DESIGN REVIEW BOARD AUGUST 19, 2016

ALPHARETTA CITY HALL
COUNCIL CHAMBERS
2 PARK PLAZA
8:30 AM

DRB1600057 SunTrust East/ Liberty Village

Staff and Downtown Architect Comments

OFFICE - OMP / NORTHWINDS

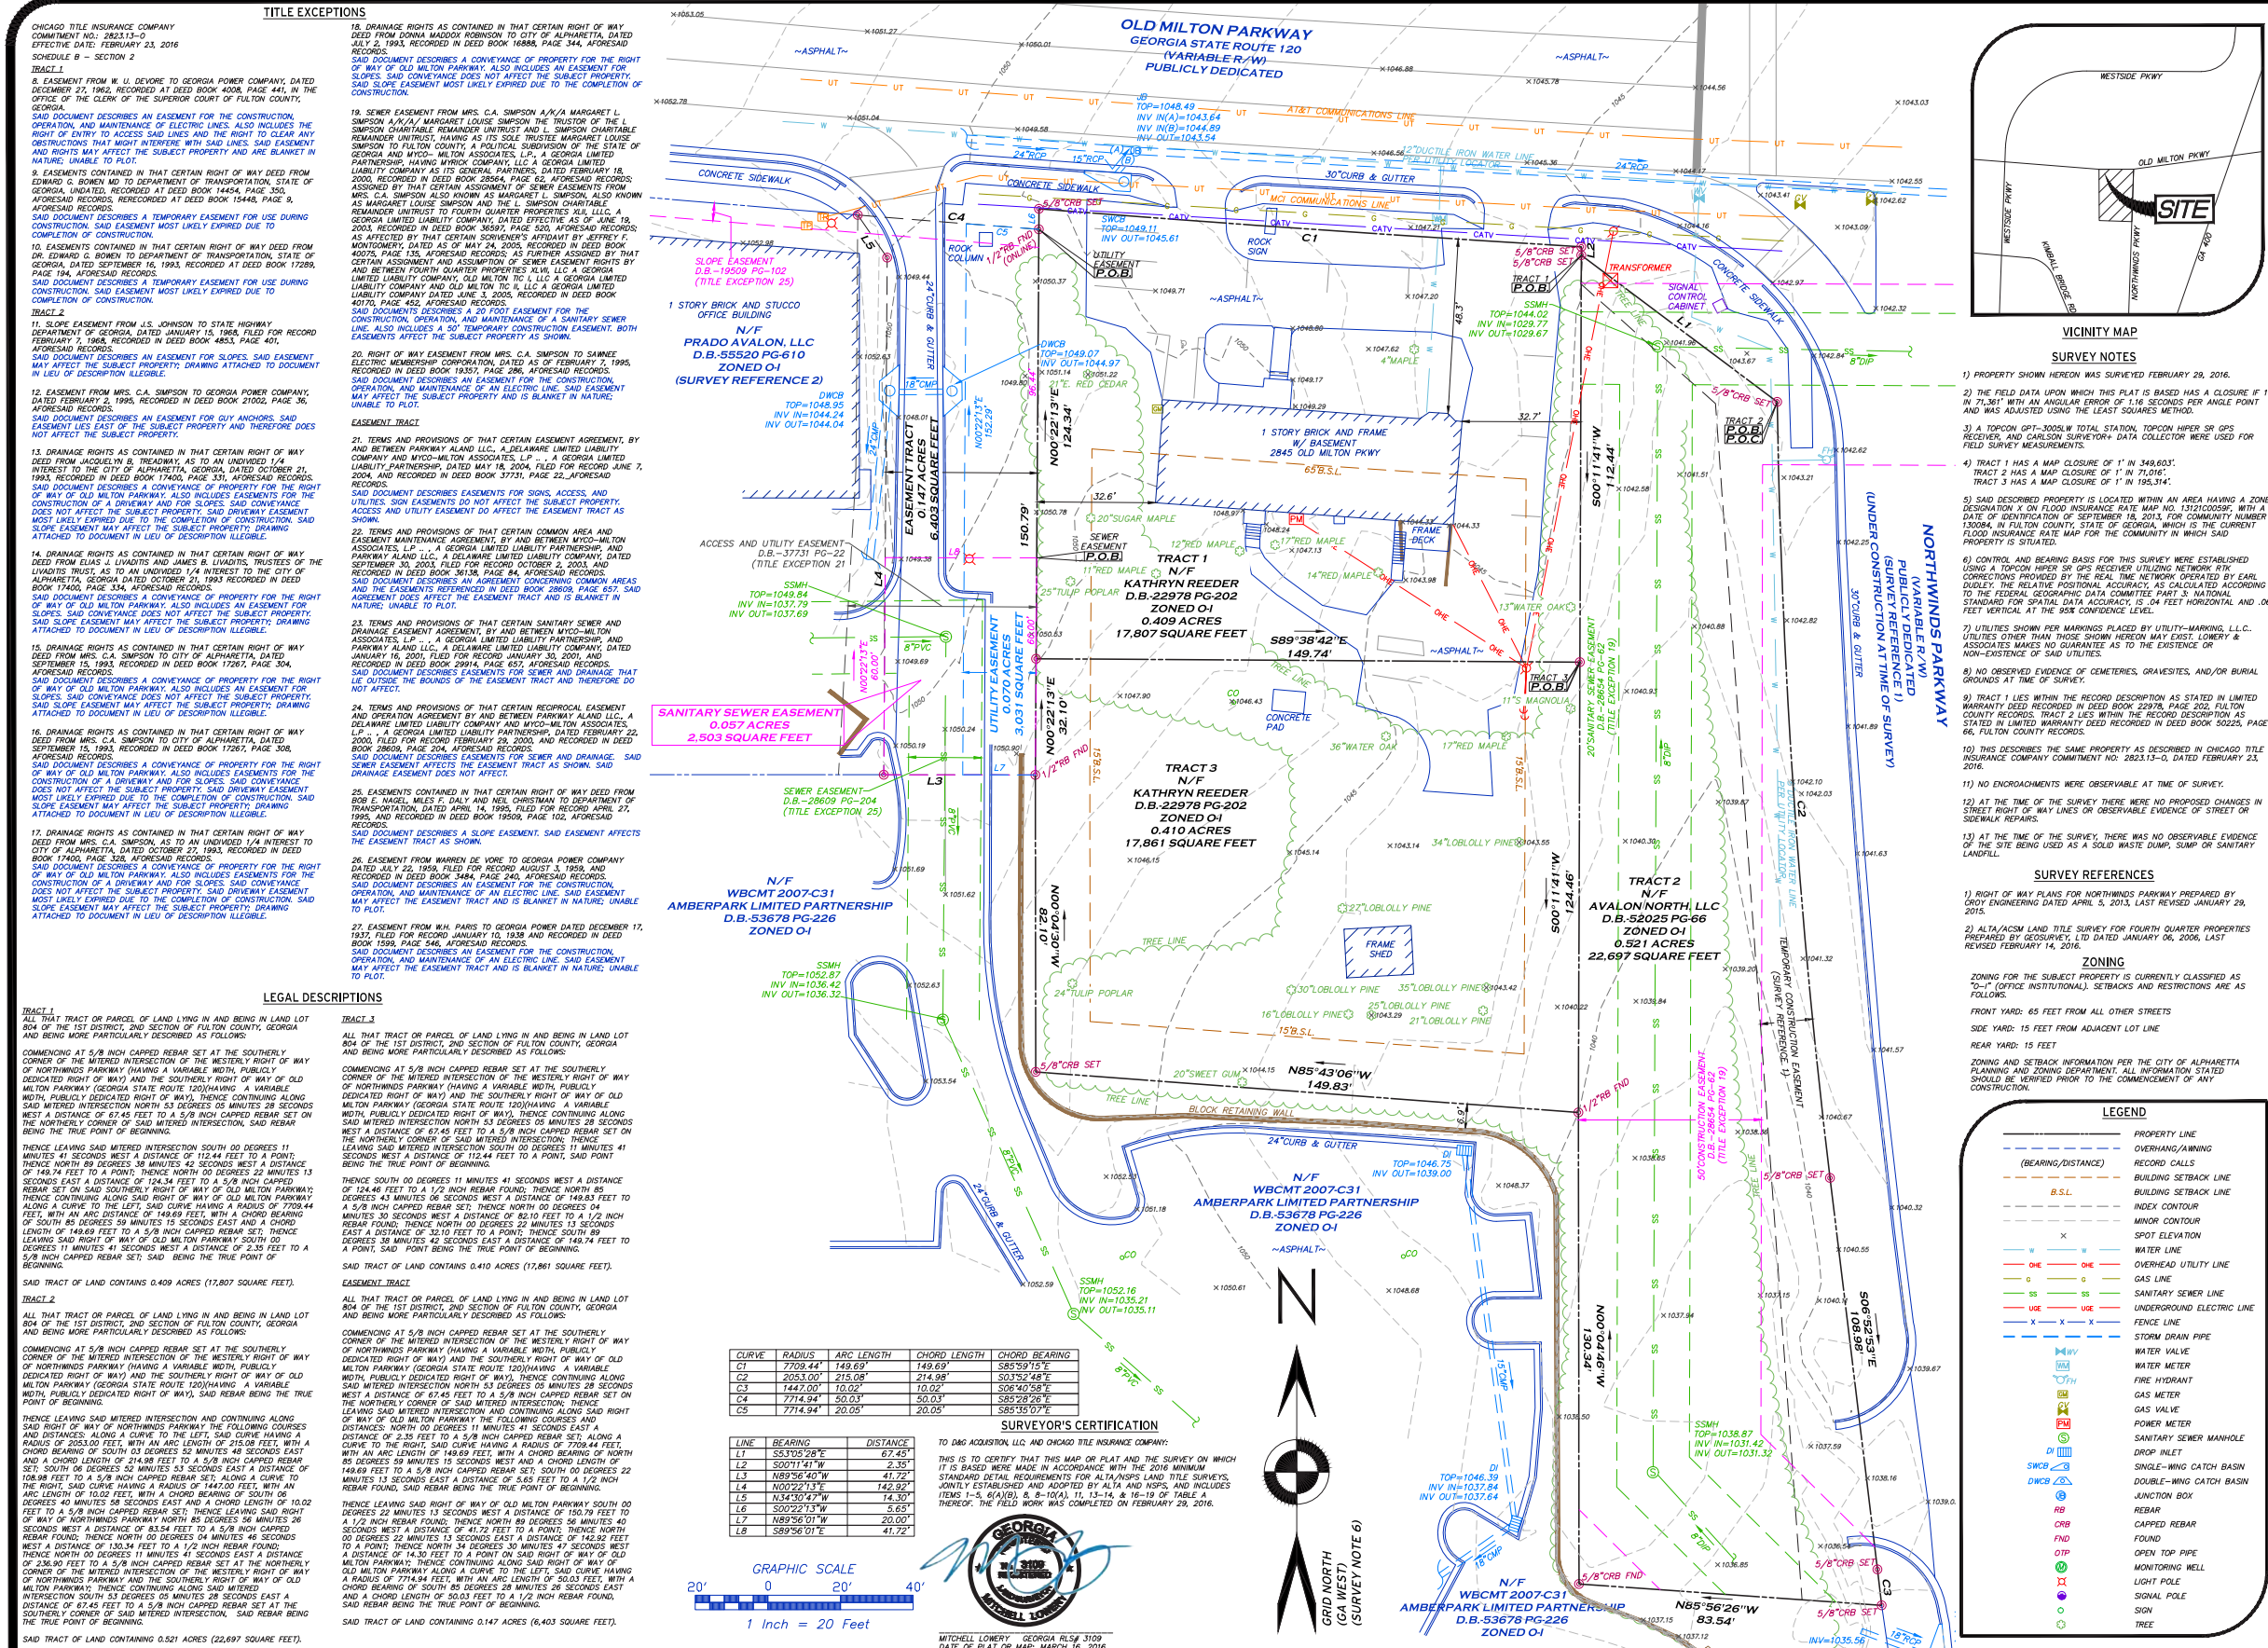
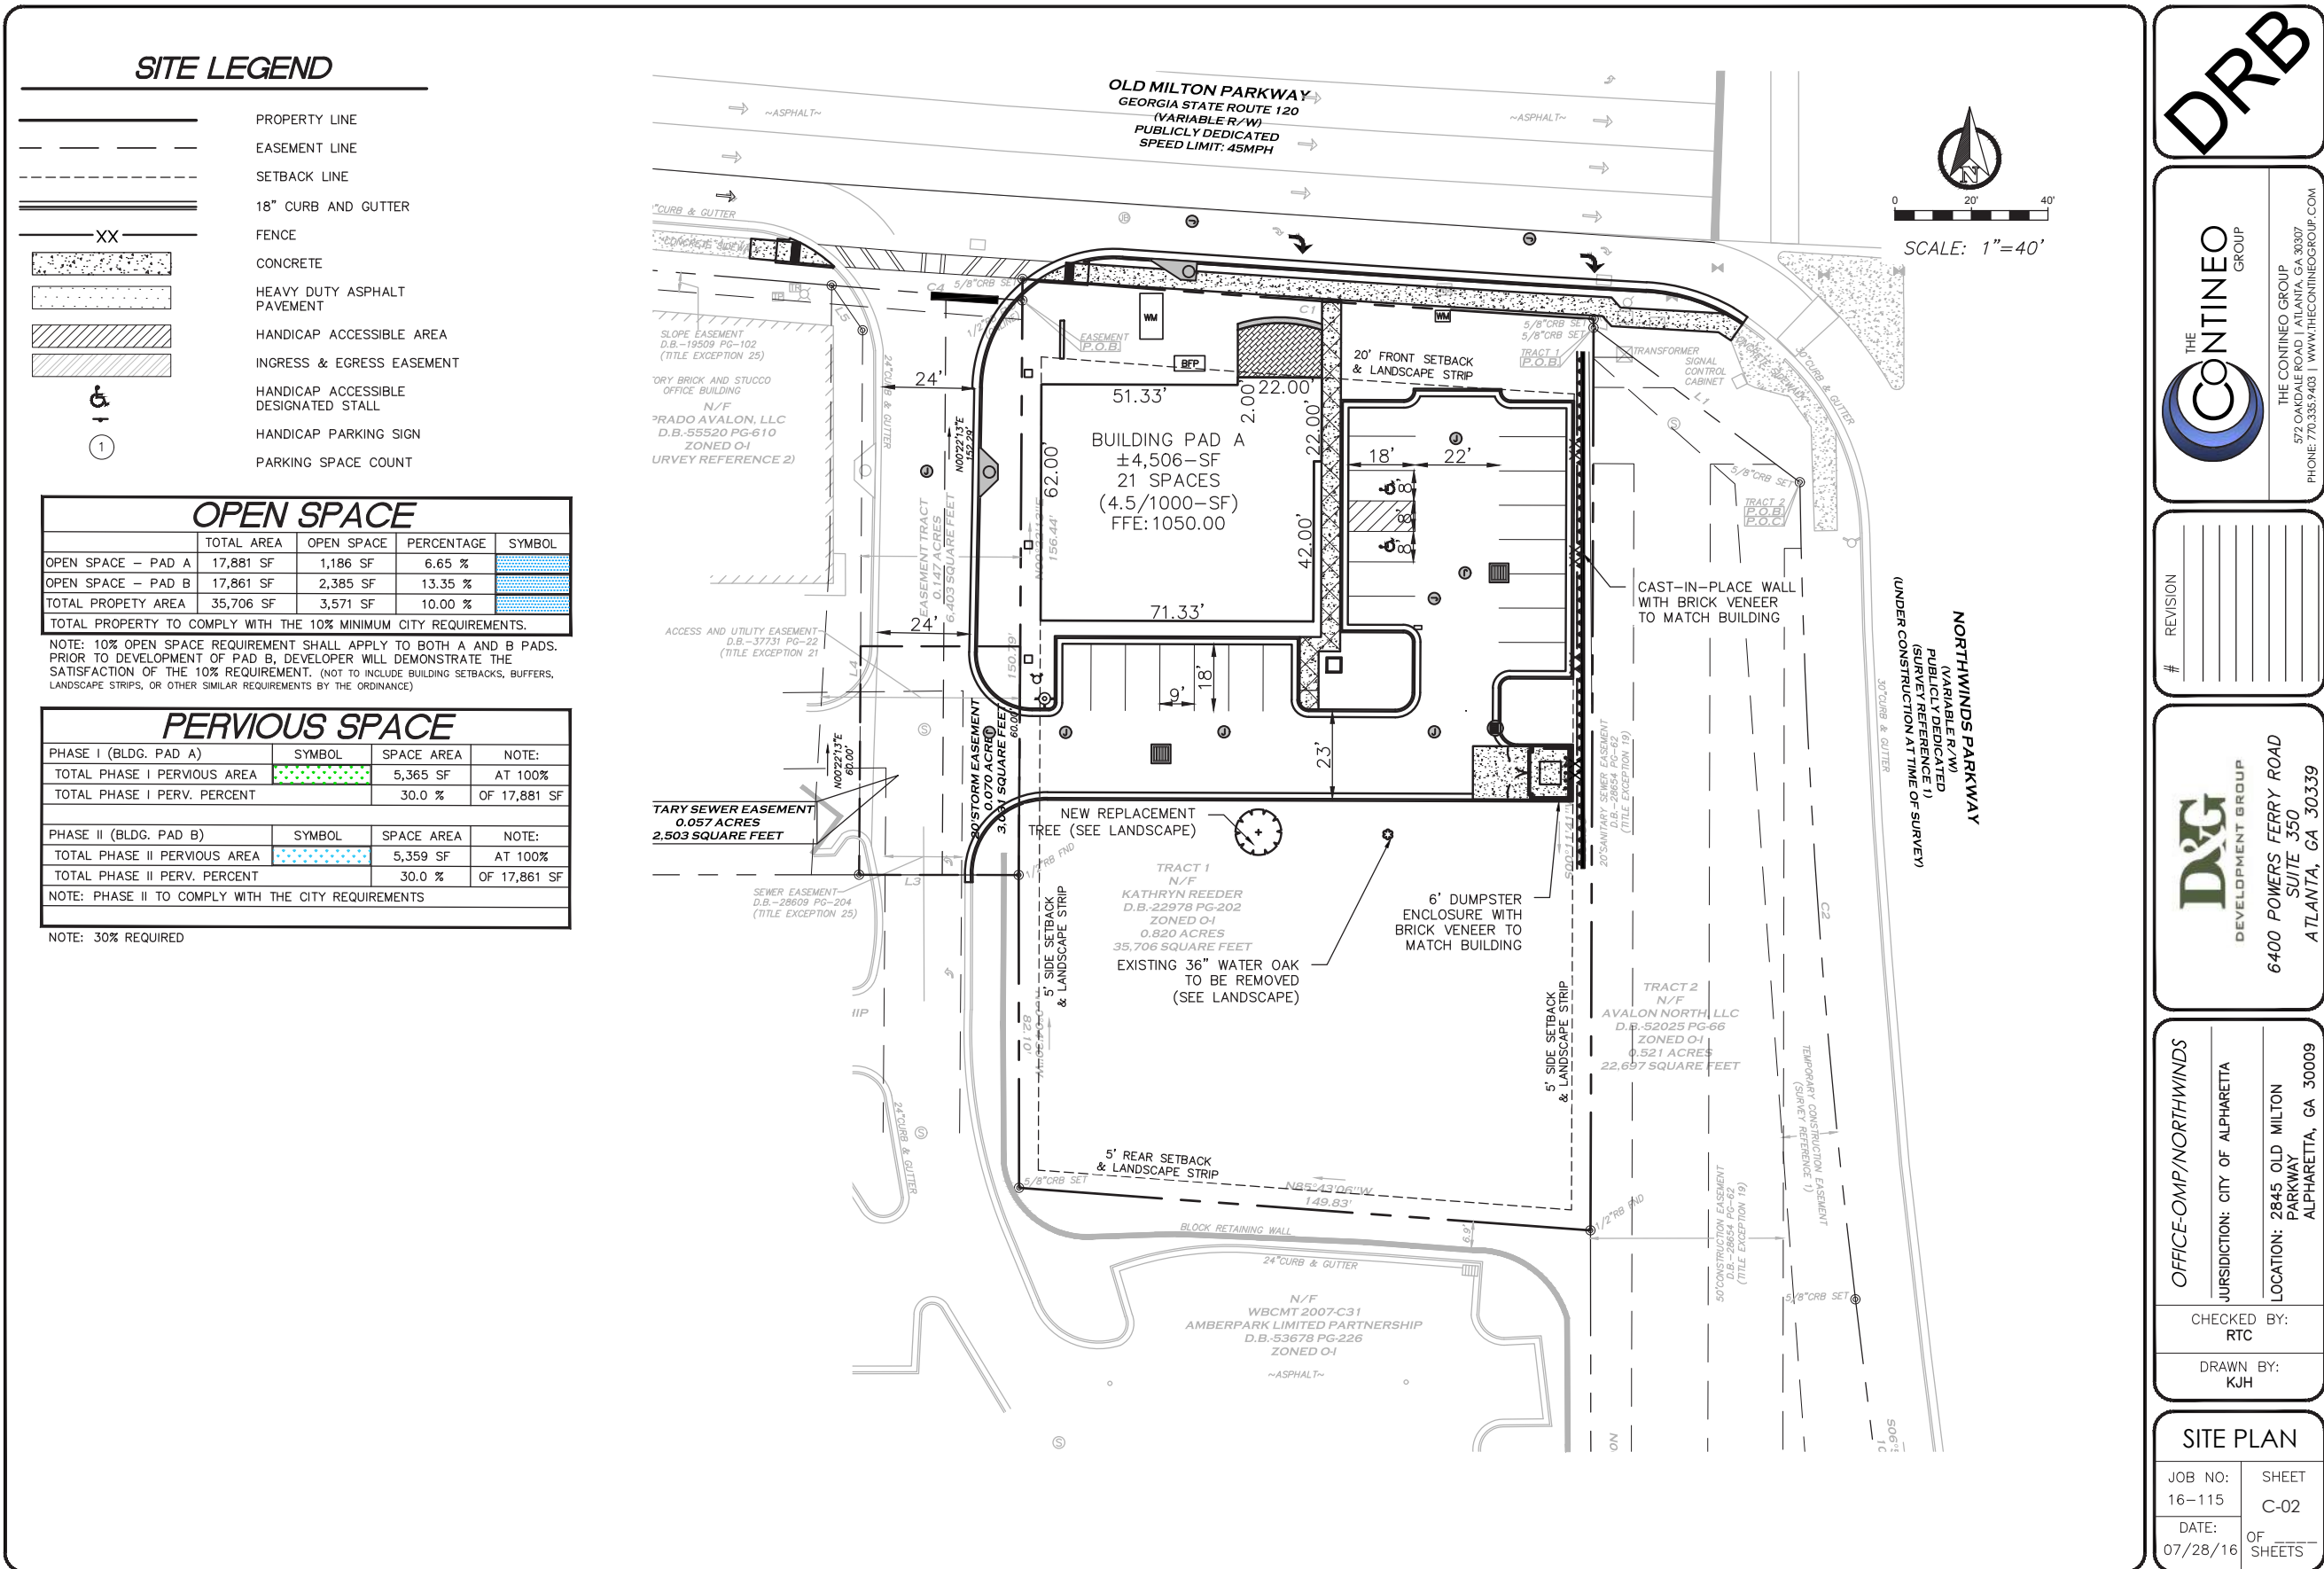
1. Verify the entrance drive trees and landscaping match existing opposite side drive.
2. Add additional screening of varied heights with a 4 foot minimum height at time of planting and maintained as such.

3. Scale on drawing seems incorrect. Verify that the 1:25 shade tree requirement along OMP is met with numbers and location near the sidewalk and spacing proper for mature sizes of trees.

4. Replace Red Maples along East property line with specie that will not affect the retaining wall and will handle the heat from parking lots Southern exposure.

5. Decorative pedestrian lighting is required along the frontages. Show style and locations on landscape plan with final approval by Staff.
6. Condition 4 say enhanced "above" the code for landscaping in the 20' strip. This should not be mostly turf. Condition 4 not met.

11. Condition 7 not met on the West facing elevation. Add windows or other architectural elements to enhance this side and not appear as the rear.
12. Condition 5 referring to the height pertains to the majority of the building. FFE of building adjacent is 1053 with a 20 foot median height. Your building height needs to be 24 feet tall minimum with the shown 1050 FFE and have an architectural feature that exceeds that height.

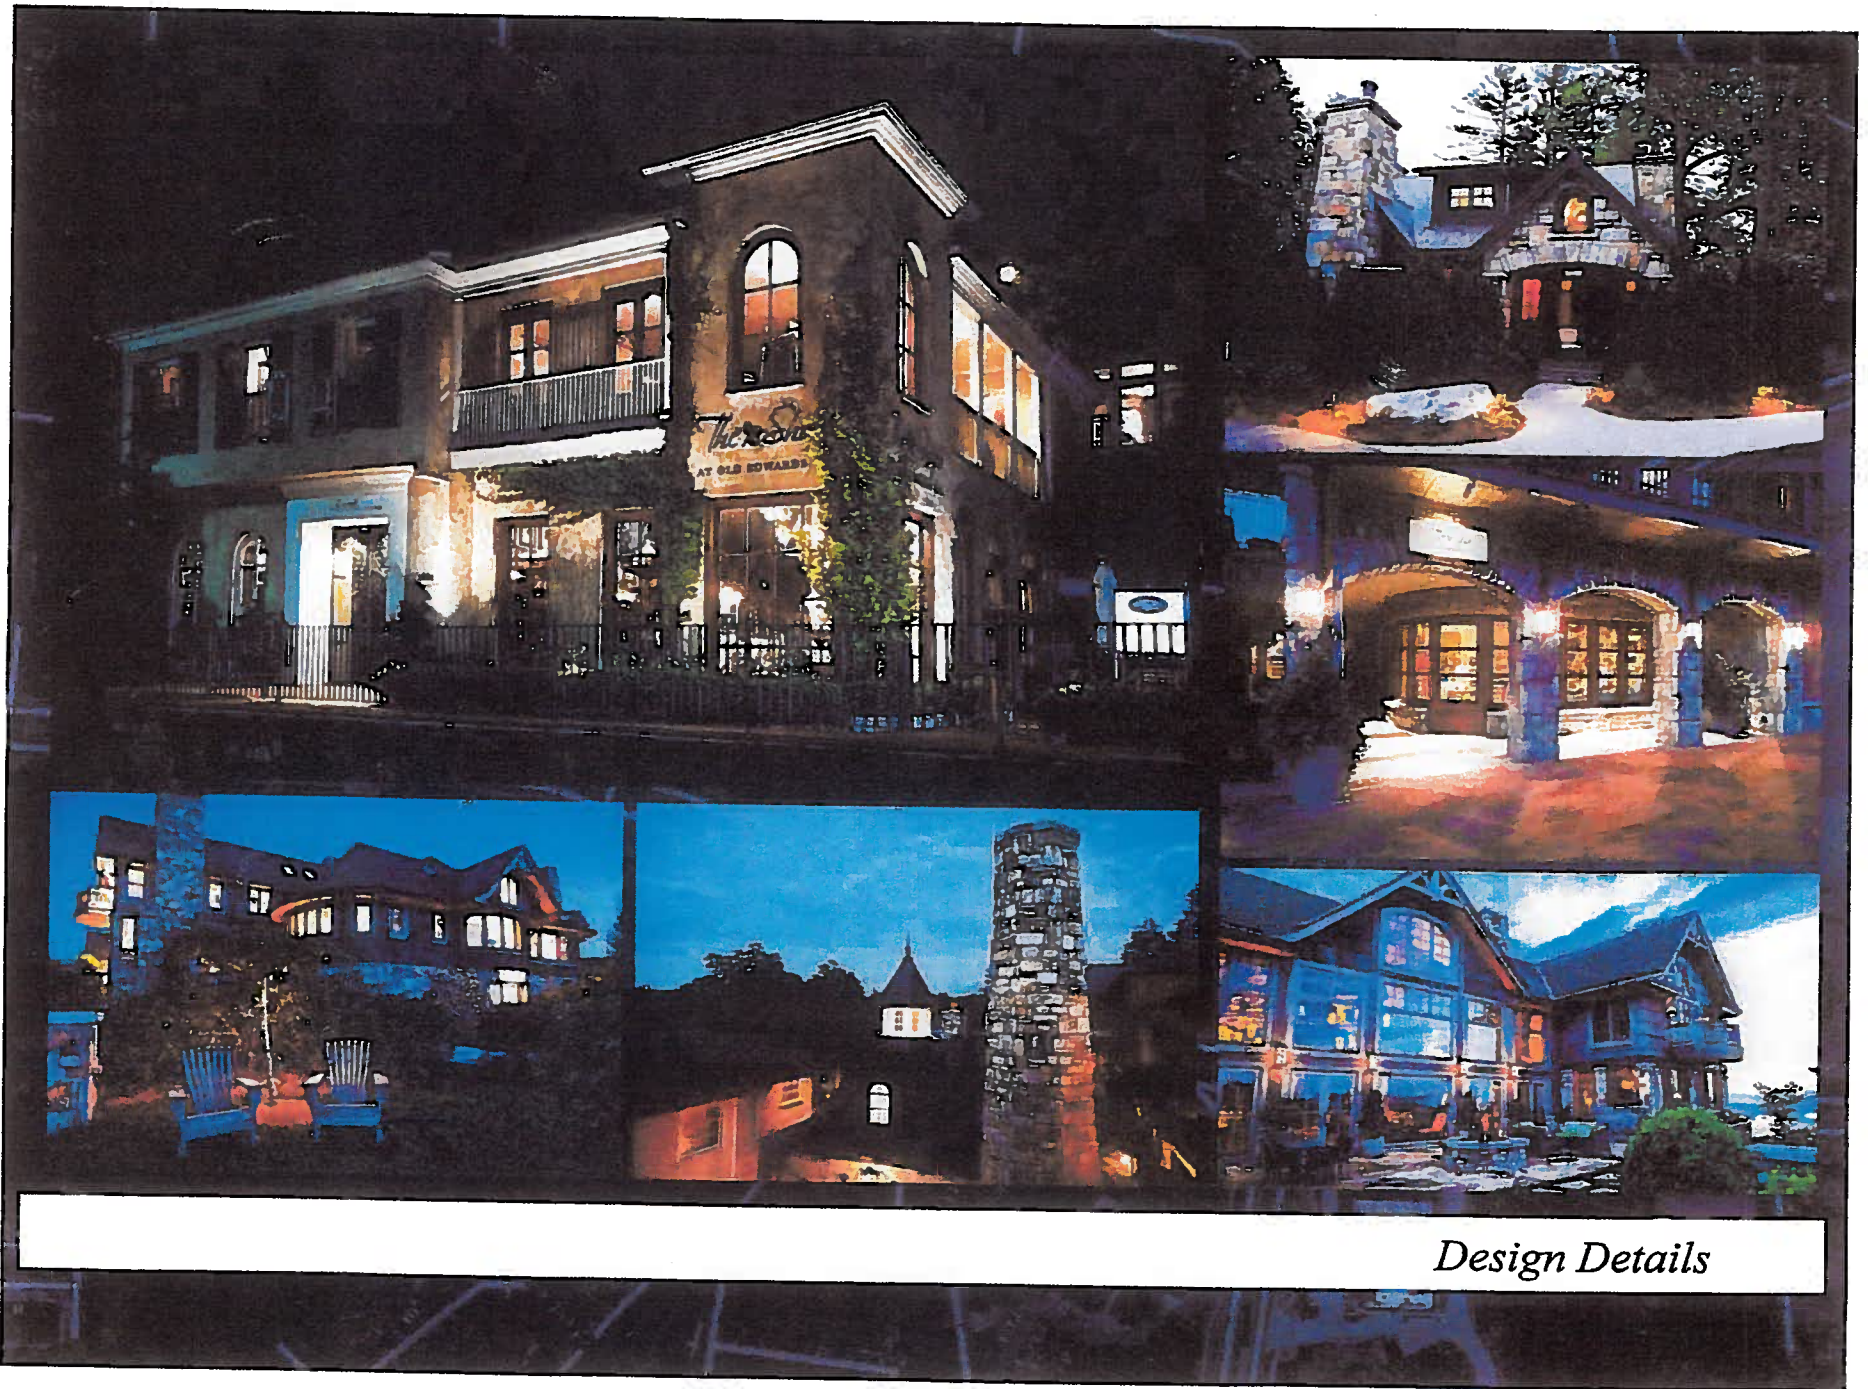
1. More variation in colors of stone and brick
2. Water Table-
Should be larger. More Earth Tone, darker, therefore heavier. Show more differentiation from brick above.
3. South Elevation – the 3 windows require masonry header details
4. Improve front door to better match Old Edwards Inn:
 - a. Remove the little shed roof over the front doors, and instead allow the main roof to come out at that point ...or have a higher portico element with wood brackets ... again better relating to the Old Edwards Inn prototype approved earlier.
 - b. Add transom above the front doors.
 - c. The result – the granite door surround (like the Inn) can be larger and more pronounced.
5. Chimney element needs historic detailing – see examples
Details tended to be heavy large stones at bottom, transitioning to smaller stones in the middle, and then brick for upper vertical stack.
